T10/07-361r3

**To** INCITS T10 Committee  
**From** Curtis Ballard, HP  
Michael Banther, HP  
**Subject** SSC-3 Out of Band Encryption Key Management  
**Date** 29 October, 2007

Figure 8 — UML example of SCSI target device and physical device

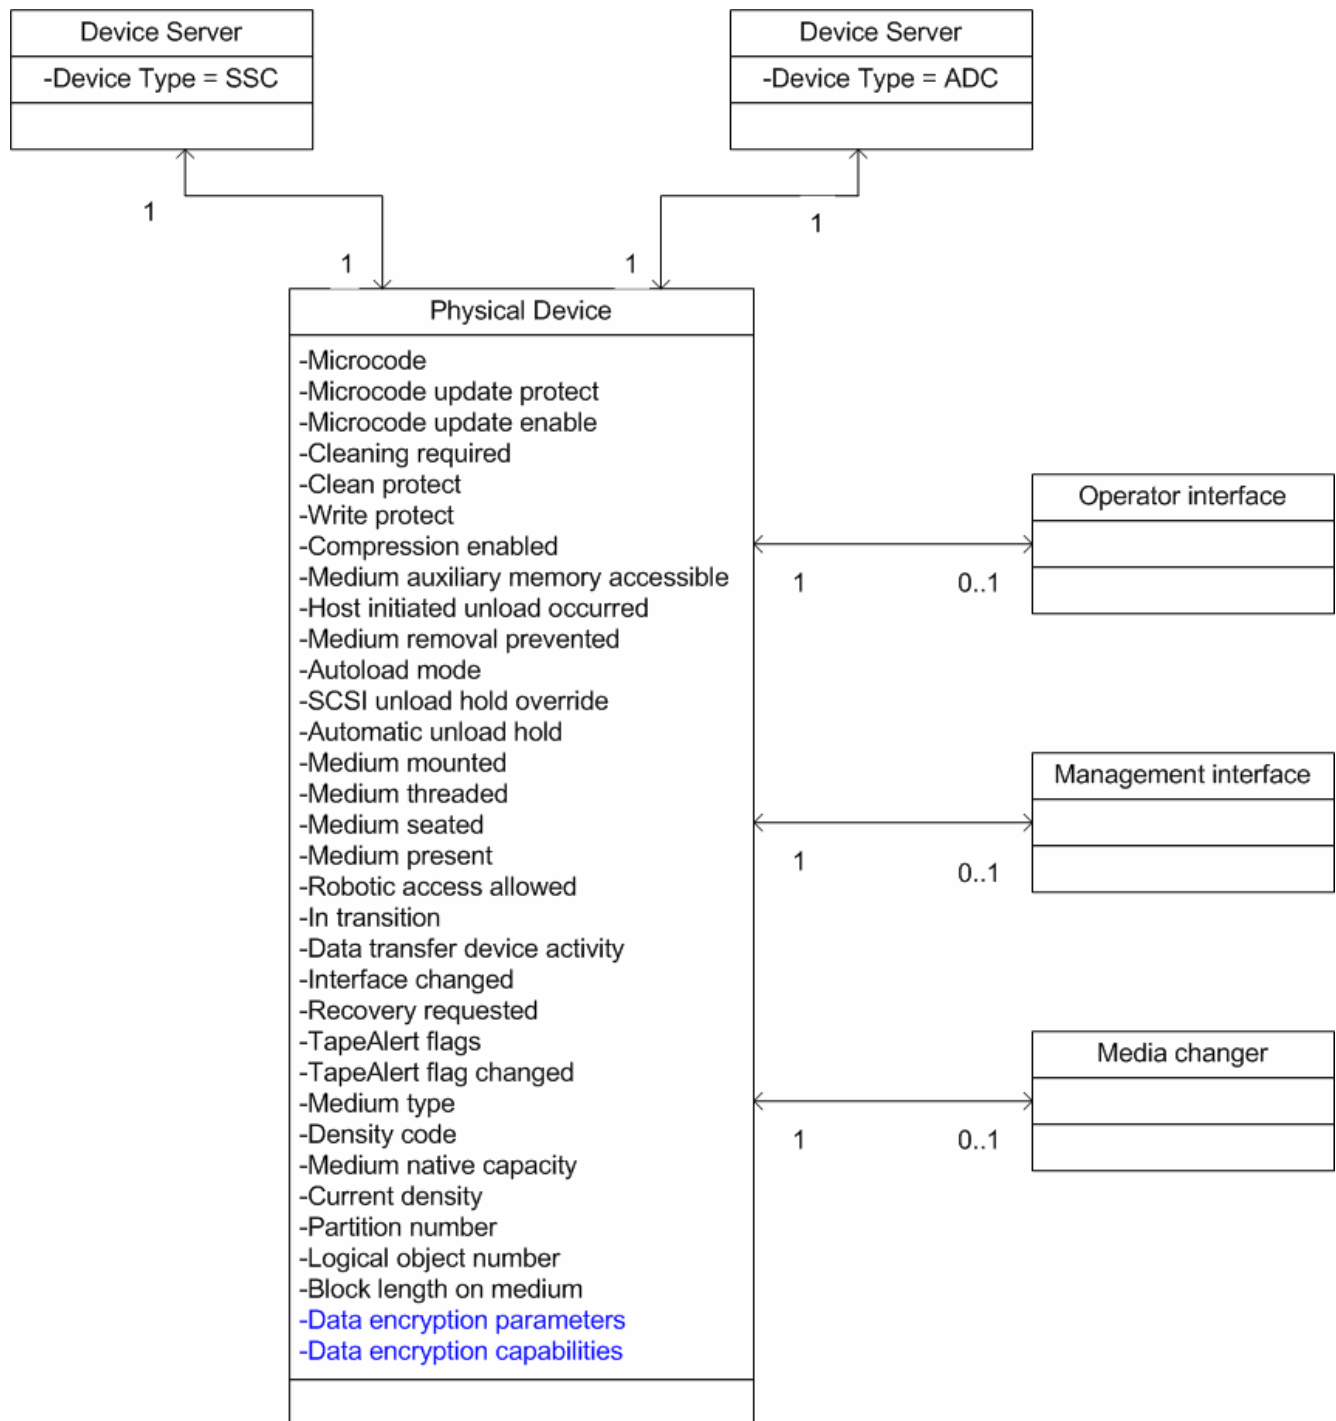
Add data encryption parameters and data encryption capabilities to list of items in physical device in figure 8.
